HISTORIC AND DESIGN REVIEW COMMISSION

HDRC CASE NO: 2019-323
ADDRESS: 412 HAYS ST
LEGAL DESCRIPTION: NCB 537 BLK 22 LOT 3
ZONING: R-6, H
CITY COUNCIL DIST.: 2
DISTRICT: Dignowity Hill Historic District
APPLICANT: Paul Franklin/Franklin Architect
OWNER: Marc Wylie/WYLIE MARC WAYNE
TYPE OF WORK: Construction of a rear accessory structure, fencing, site work
APPLICATION RECEIVED: May 31, 2019
60-DAY REVIEW: July 30, 2019
CASE MANAGER: Edward Hall
REQUEST:

The applicant is requesting a Certificate of Appropriateness for approval to construct a detached accessory structure at the rear of the lot. The proposed rear accessory structure is to feature one story in height and a footprint of approximately 680 square feet.

1 ARCHITECTURAL SITE PLAN

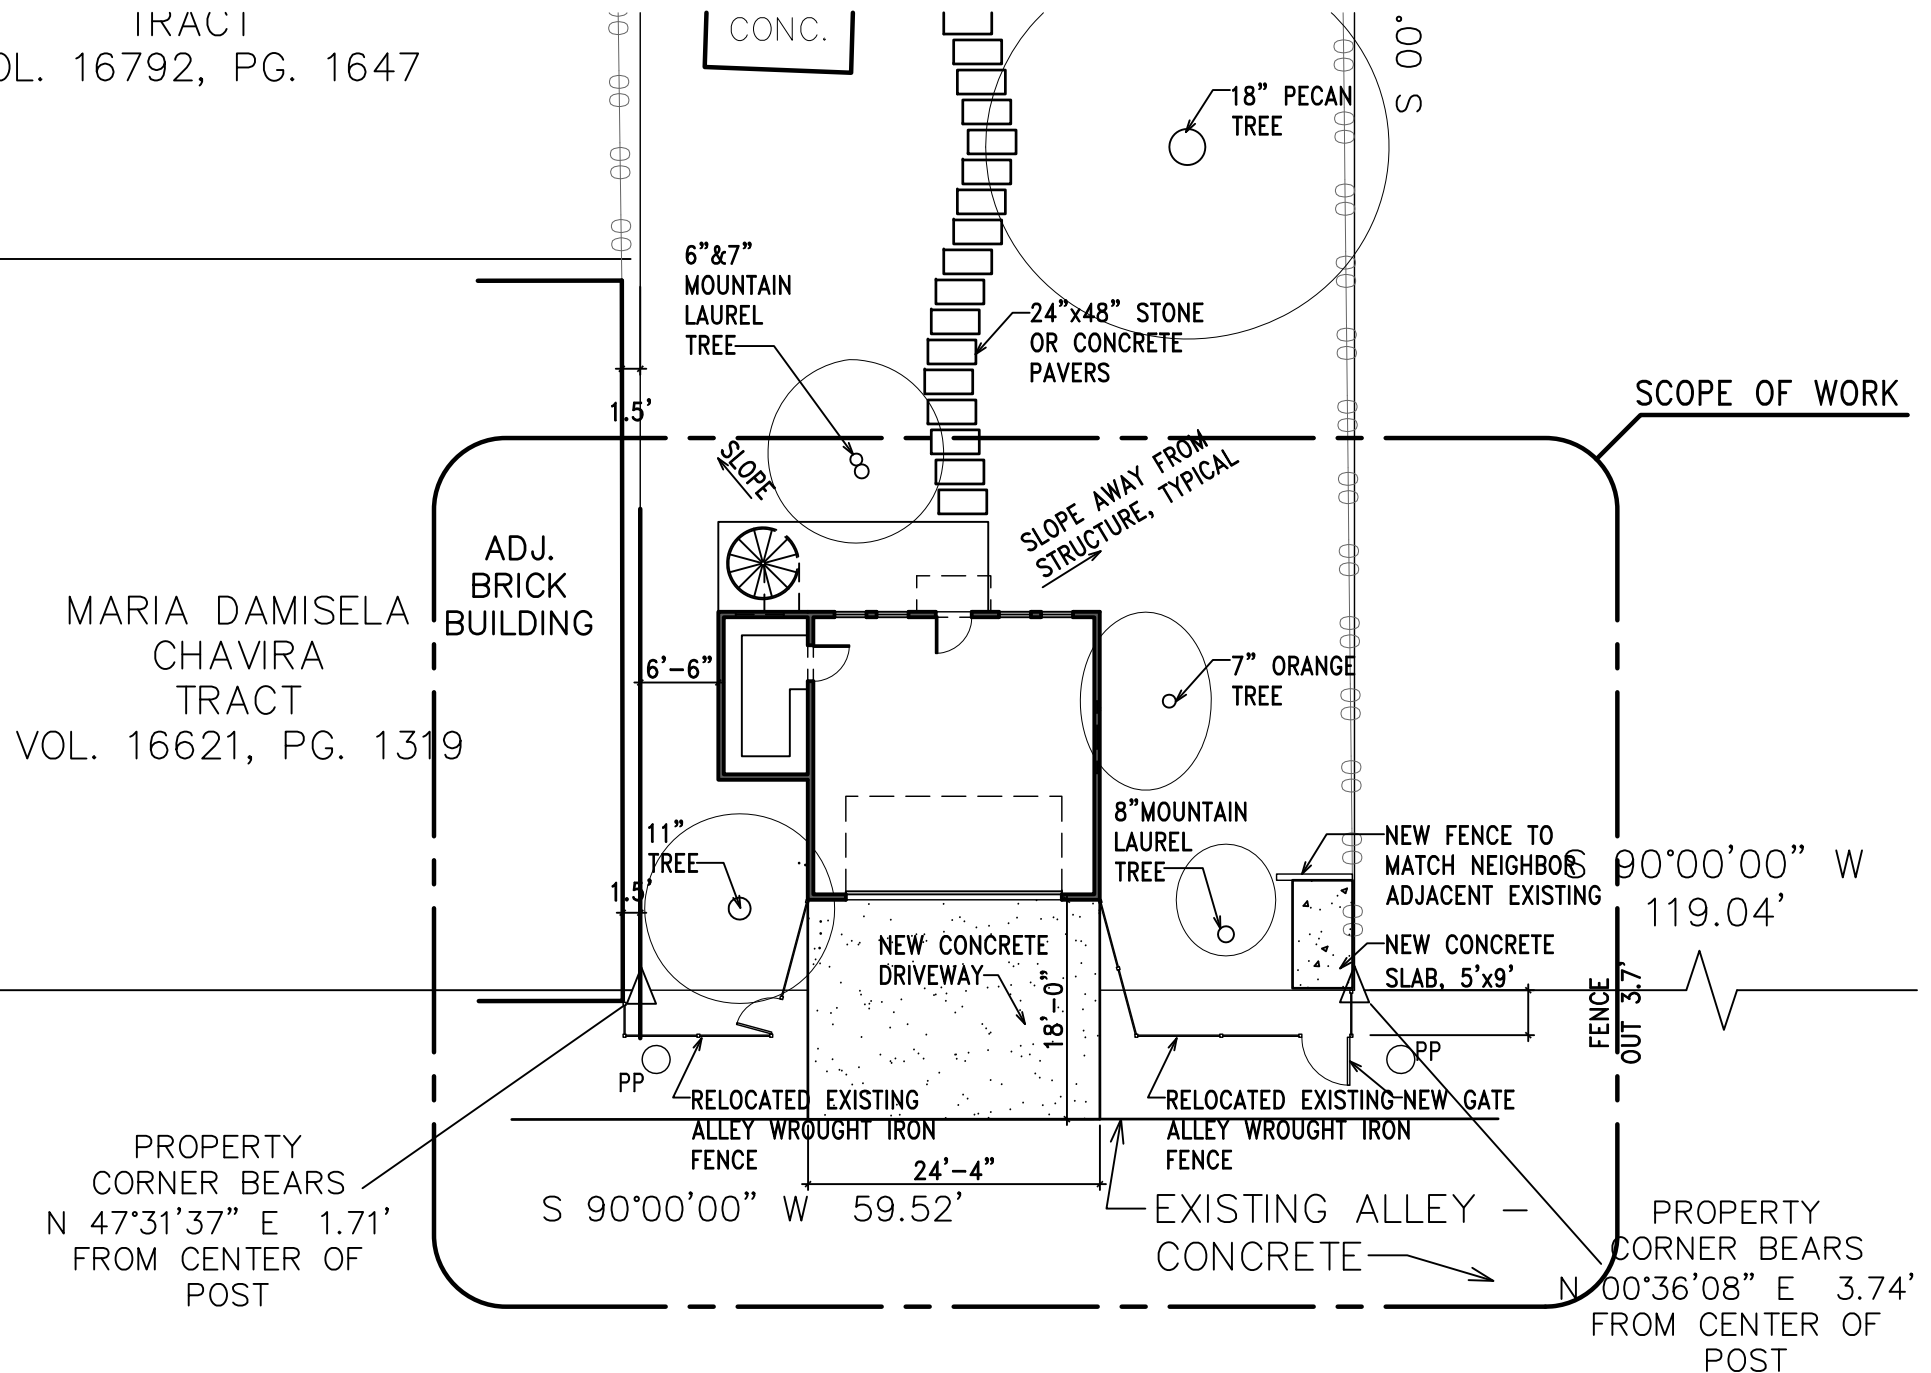
- i. **SITE WORK** – The applicant has proposed to install a driveway that features a width of 24’ – 4”. Existing driveways and aprons on Armadillo Alley feature widths of approximately eight to fourteen feet in width. Staff finds the proposed driveway width to be inconsistent with the Guidelines, which notes that existing driveway widths and profiles should be matched. Staff finds that the applicant should explore ways to reduce the proposed driveway’s width, or incorporate alternative materials as to not feature more than ten (10) feet of continuous concrete paving.

- ii. That the applicant should explore ways to reduce the proposed driveway’s width, or incorporate alternative materials as to not feature more than ten (10) feet of continuous concrete paving.

WINDOW: ONE-OVER-ONE

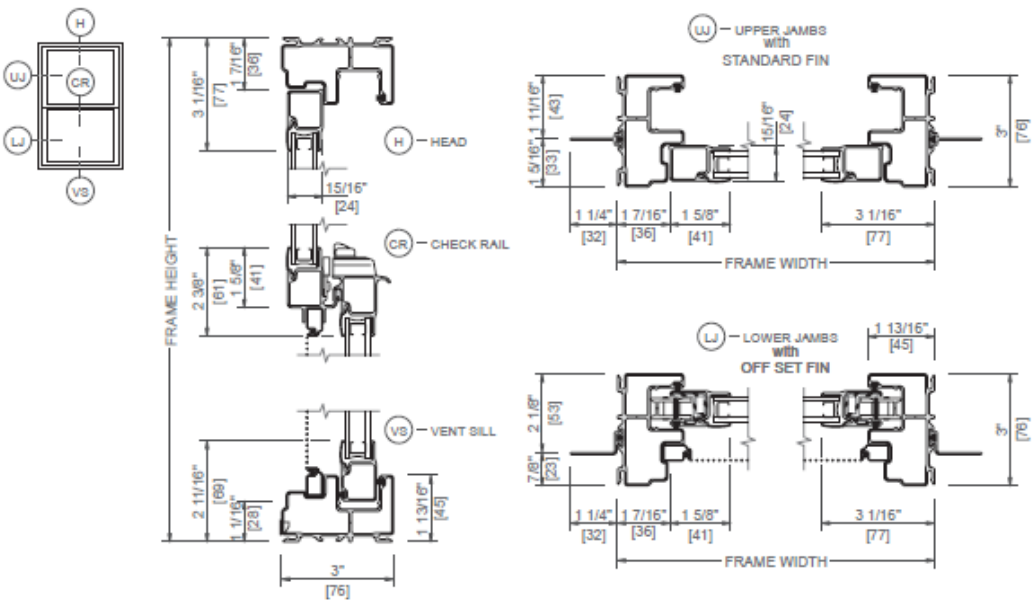
- h. **WINDOW MATERIALS** – The applicant has proposed fiberglass windows. Staff finds that a double-hung, one-over-one wood windows or aluminum-clad wood windows be used.. Meeting rails must be no taller than 1.25” and stiles no wider than 2.25”. White manufacturer’s color is not allowed, and color selection must be presented to staff. There should be a minimum of two inches in depth between the front face of the window trim and the front face of the top window sash. This must be accomplished by recessing the window sufficiently within the opening or with the installation of additional window trim to add thickness. Window trim must feature traditional dimensions and architecturally appropriate sill detail. Window track components must be painted to match the window trim or concealed by a wood window screen set within the opening.

- i. That the applicant install wood or aluminum clad wood windows that feature meeting rails that are no taller than 1.25” and stiles no wider than 2.25”. White manufacturer’s color is not allowed, and color selection must be presented to staff. There should be a minimum of two inches in depth between the front face of the window trim and the front face of the top window sash. This must be accomplished by recessing the window sufficiently within the opening or with the installation of additional window trim to add thickness. Window trim must feature traditional dimensions and architecturally appropriate sill detail. Window track components must be painted to match the window trim or concealed by a wood window screen set within the opening.
